A complete solution for Ford Mondeo I+2!

Stabilizer mounting repair kit (with clamps) SWAG 50 92 7400

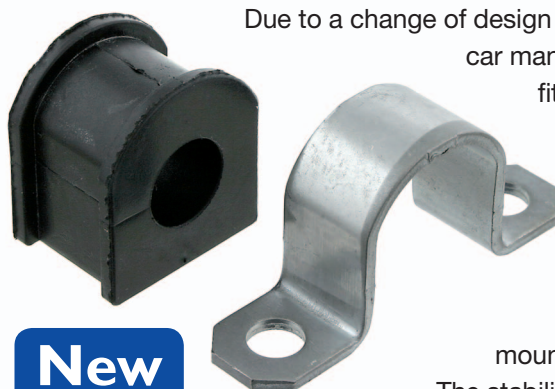
Due to a change of design of the anti roll bar mounting by the car manufacturer, problems occurred when fitting the stabilizer mounting (SWAG 50 92 1855).

The former semi-circular design has now been changed to a flat design identical to the original part (see picture 3). This means the mounting clamp must also be changed.

The stabilizer mounts and clamps (SWAG 50 92 7355) should always be replaced in pairs to ensure a professional level of servicing.

This repair kit contains stabilizer mounts with matching mounting clamps as well as the required high tensile mounting screws (10.9 grade).
